TECHNICAL EVALUATION REPORT

HYDROLOGICAL CONSIDERATIONS

SOUTHERN CALIFORNIA EDISON COMPANY
SAN ONOFRE NUCLEAR GENERATING STATION UNIT 1

NRC DOCKET NO. 50-206

Figure 3. Plant Structures

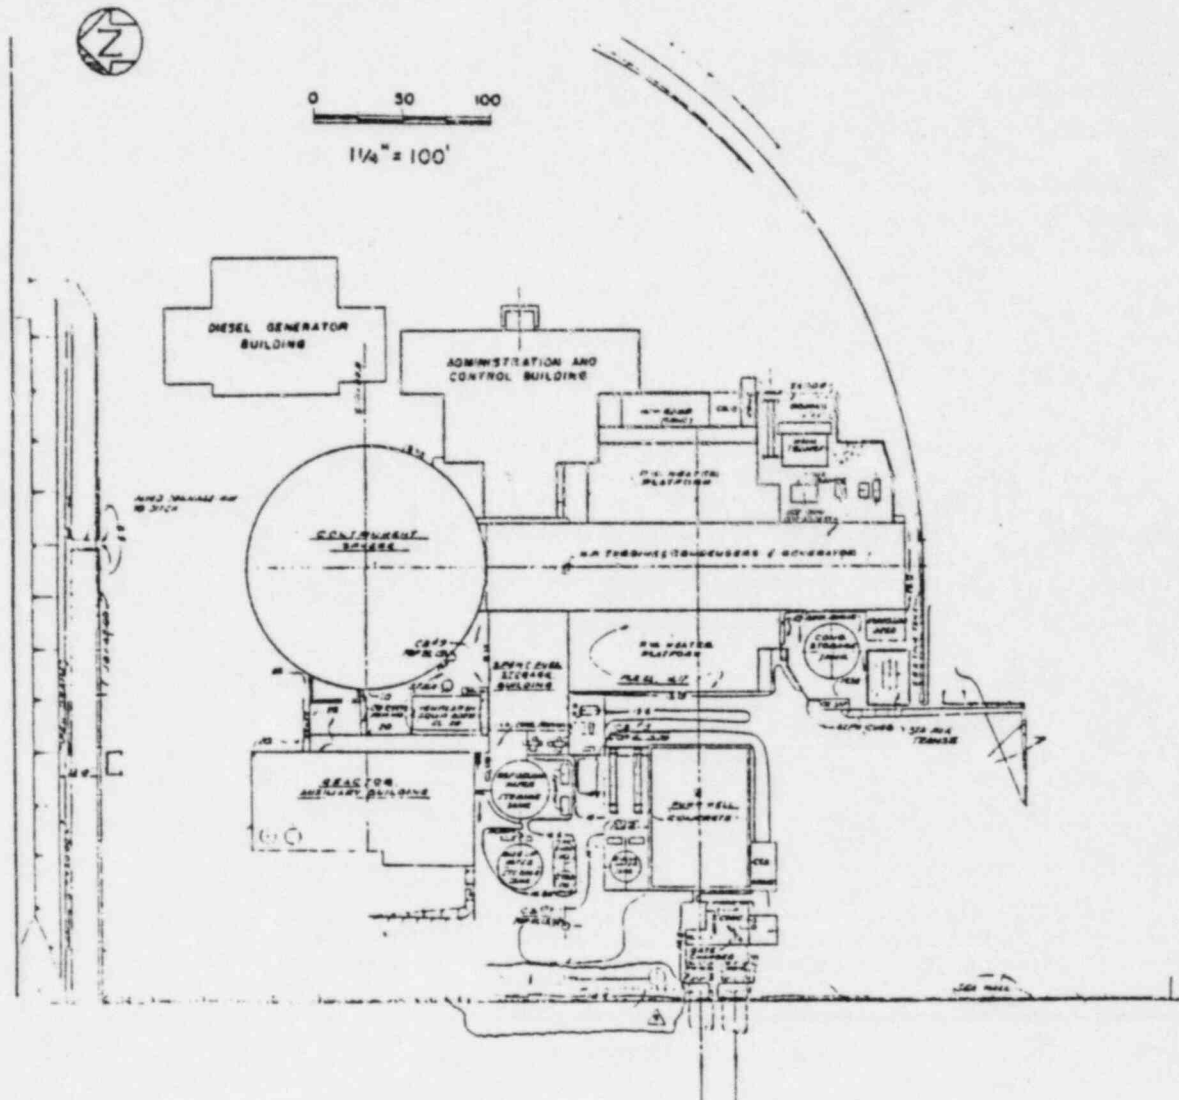
The Licensee states [16] that the control building, the reactor auxiliary building, the sphere enclosure building, and the post-accident sampling building have no parapets or are below grade with the surface graded for free drainage. Review of plant drawings [15] shows that the sphere enclosure building is free-draining, and that there are no parapets around the roof of the control and administration building. There are, instead, extruded aluminum gravel stops around the edges of the control and administration building, and a difference in elevation of 3 inches between the low points at the drains and the high points around the perimeter of the roof. This confirms the Licensee's conclusion that the control building roof design basis loading will not be exceeded during PMP.

The Licensee has stated [16] that the diesel generator building roof is designed to withstand the load resulting from water ponded to the top of the parapets, which are 9 to 12 in above the roof. Plant drawings [15] and a site visit by reviewers [18] also show that the parapets are 9 in above the high points and 12 in above the low points of the diesel-generator building roof. Therefore, water will not pond higher than 12 in, or higher than the design basis, according to the Licensee. The design basis of the diesel generator

In response to a request for additional information, the Licensee stated [16] that the design basis for live loading on the roof of the fuel storage building, expressed in inches of ponded water, is less than the height of the parapets. The parapet height on the fuel storage building varies between 8 and 14 in. Plant drawings [15] show that the parapet extends to 10 in above the high points of the top of steel and 16 in above the low points of the top of steel. The Licensee further stated [16] that, in addition to two drains at the low points of the roof, a 2 in x 8 in scupper is located above each drain. According to plant drawings, these scuppers are situated on the north and south sides of the structure between elevations 65 ft and 65 ft 2 in. These openings are adequate to ensure that ponding on the rooftop during PMP does not exceed a depth of 9 inches.

The Licensee states that parapet height on the ventilation building varies from 10 in above the high points of the roof to 15 in above the drain at the low point of the roof. A 2 in x 8 in scupper is located over the drain [16]. Plant drawings confirm this information, and show the scupper on the east wall of the ventilation building extending horizontally between 5 and 7 in above the low point of the top of roof steel [15]. This scupper is sufficient to ensure that rainwater during PMP does not pond more than 7.5 in above the low points of the roof.

Since the Licensee has failed to provide the design basis live loading of the ventilation building rooftop, compliance with current NRC criteria cannot be determined. However, the roof is designed so that loading from PMP stormwater will not exceed 38.9 psf.

Figure 5. Onsite Drainage Map

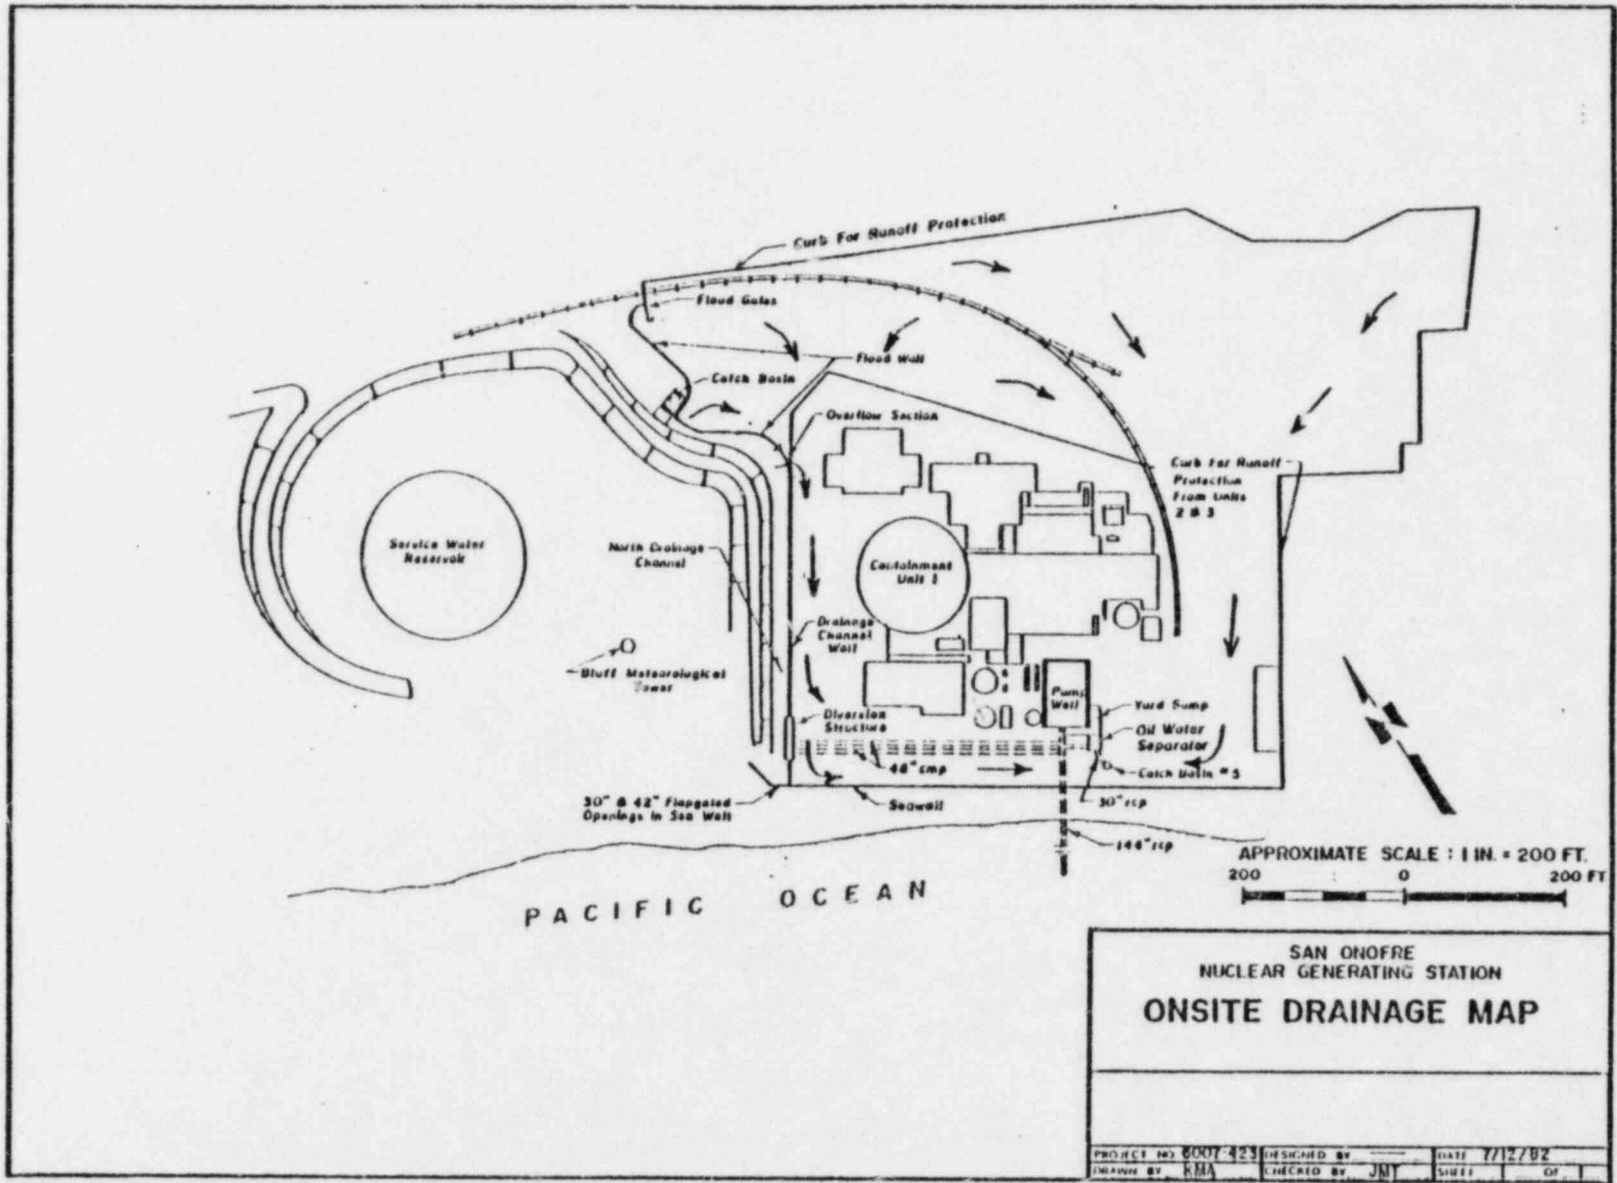
Within the onsite drainage area is the yard drainage system that collects runoff and conveys it underground to the oil-water separator and then to the Pacific Ocean. Once the open-grating manhole cover for catch basin 5 is submerged by floodwaters, the seaward discharge from the yard drainage system is controlled hydraulically by the 30-in-diameter reinforced-concrete pipe (SCE Drawing No. 5153114-1) [15] that connects catch basin 5 with the oil-water separator.

The second onsite drainage system, identified in Figure 5, is a yard sump that discharges into the cold water intake structure. This system is controlled hydraulically by the limiting box culvert size of 3 ft x 5 ft. A schematic drawing of the yard sump showing the shape and dimensions of the outflow structure can be seen on Figure 6.

Figure 8. Tsunami Wall Plan

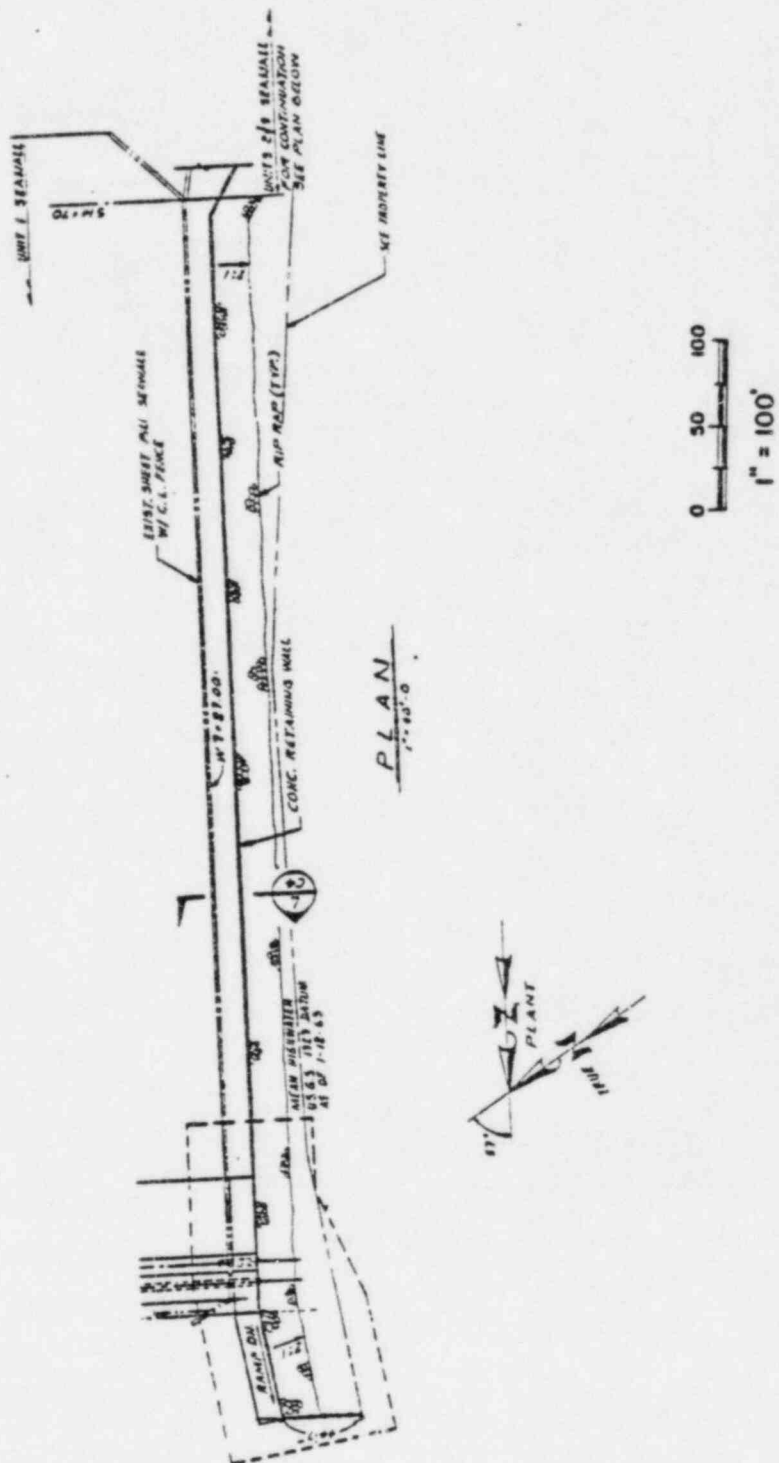
It has previously been demonstrated that the PMT will cause failure of the steel sheetpile seawall if the walkway, the walkway retaining wall, and the riprap berm do not exist [24]. The Licensee claims that the walkway complex, with riprap berm, will withstand the PMT wave forces and reduce the impact on the sheetpile seawall so that failure does not occur and protection of the plant structures is maintained [17]. The issues addressed in this report are (1) whether the walkway retaining wall and riprap berm will withstand the PMT and (2) whether the walkway retaining wall and riprap berm will prevent failure of the sheetpile seawall.

Figure 10. Tsunami Wall with Wave Forces

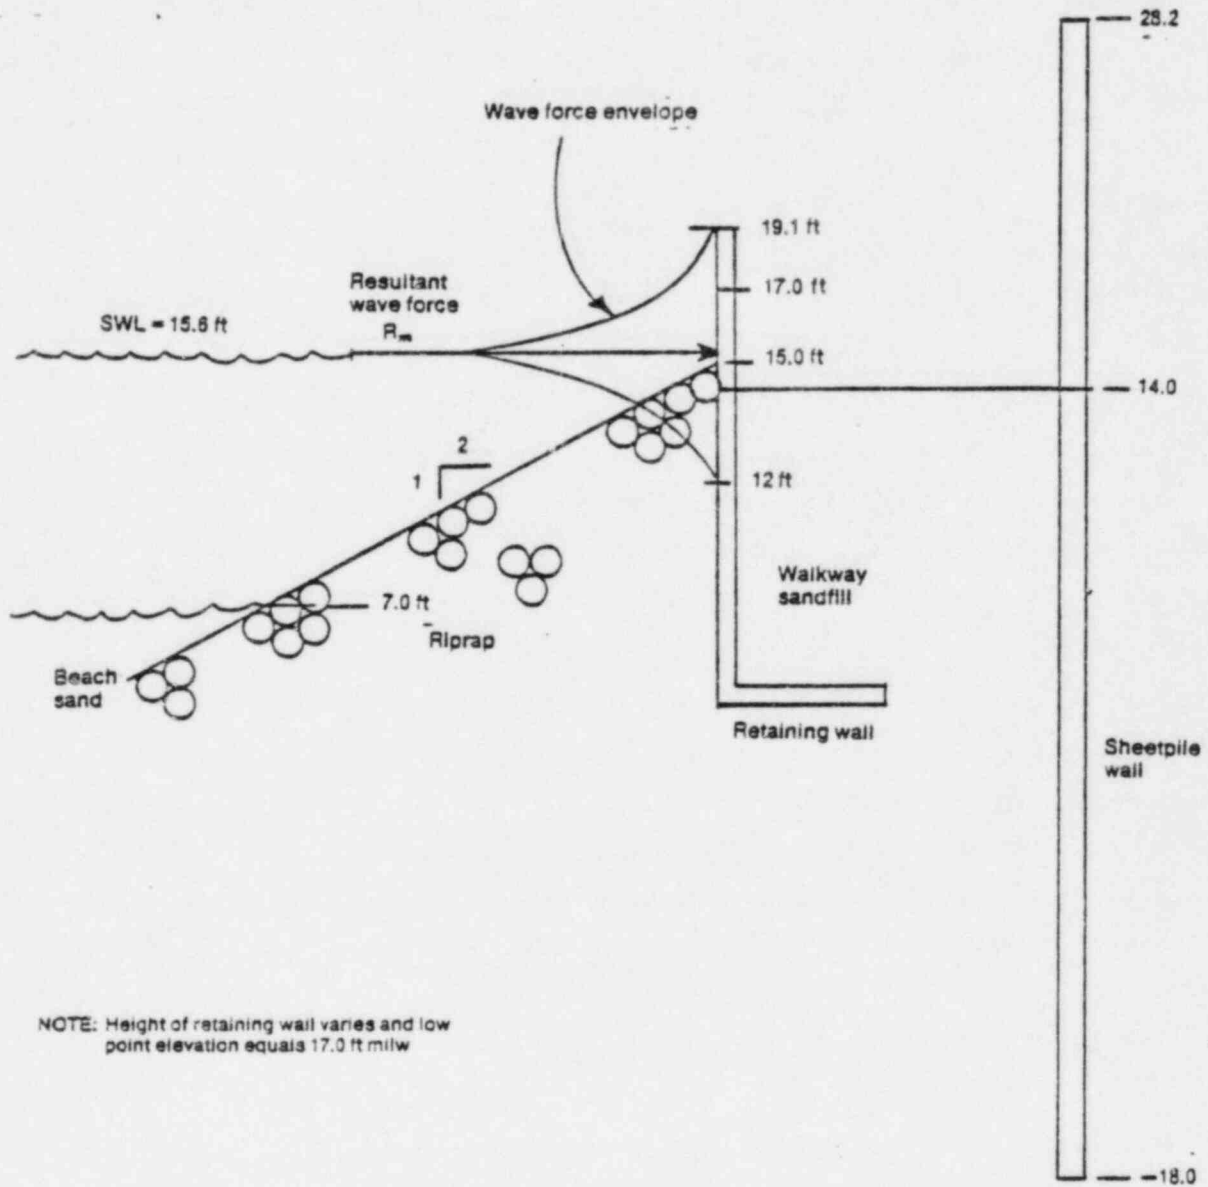
A conservative analysis of the wave and hydrostatic forces on the seawall is provided in Appendix A. It shows that the riprap berm and the walkway retaining wall will withstand the impact of the PMT and storm waves. Appendix A also provides an analysis of the wave forces assuming the upper portion of

the walkway retaining wall fails at elevation 15.0 ft mllw. It demonstrates that the riprap berm and the sand and debris from the failed retaining wall and walkway reduce the hydrodynamic force on the sheetpile seawall to 3200 lb/ft acting at elevation 15.6 ft mllw, as developed by the Licensee [16] and confirmed by the analysis in Appendix A. The hydrostatic force is 832 lb/ft, acting at elevation 15.7 ft mllw. The lowest ground level on the landward side of the sheetpile seawall is believed to be 11 ft mllw [24], and the bending stress in the sheetpile wall, caused by moment of those two forces about a point at elevation 11 ft mllw, is 7.4 ksi. This value is far below the allowable stress of 25 ksi, the minimum yield stress of 38.5 ksi, and the allowable stress including an increase for seismic loading of 40 ksi, all specified for the sheetpile section by the Licensee [16].
